3. Trust Land Survey 2025-06 Jasper Subdivision; KPB File 2025-134 Fixed Height / Alaska Mental Health Trust Authority Location: Bastien Drive

ITEM #3 - PRELIMINARY PLAT Trust Land Survey 2025-06 Jasper Subdivision

KPB File No.	2025-134
Plat Committee Meeting:	October 27, 2025
Applicant / Owner:	Alaska Mental Health Trust Authority of Anchorage, AK
Surveyor:	Buku Saliz / Fixed Height LLC
General Location:	Nikiski Area / Nikiski APC

Vicinity Map 9/12/2025

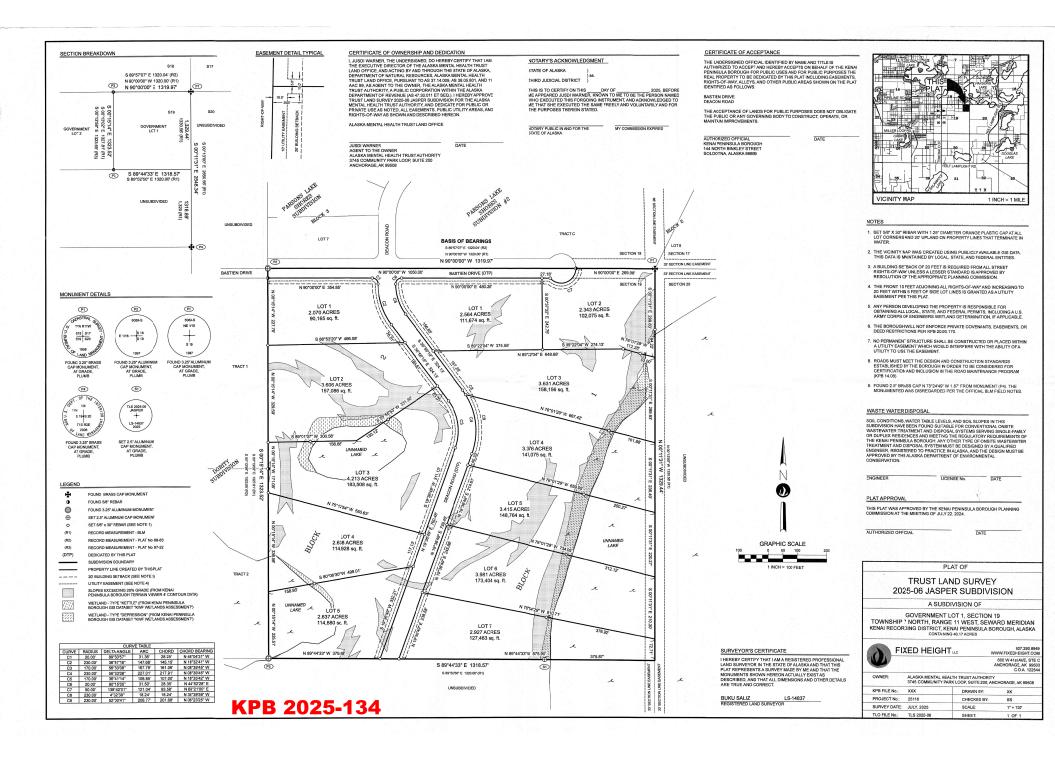
Add some road names to the vicinity map
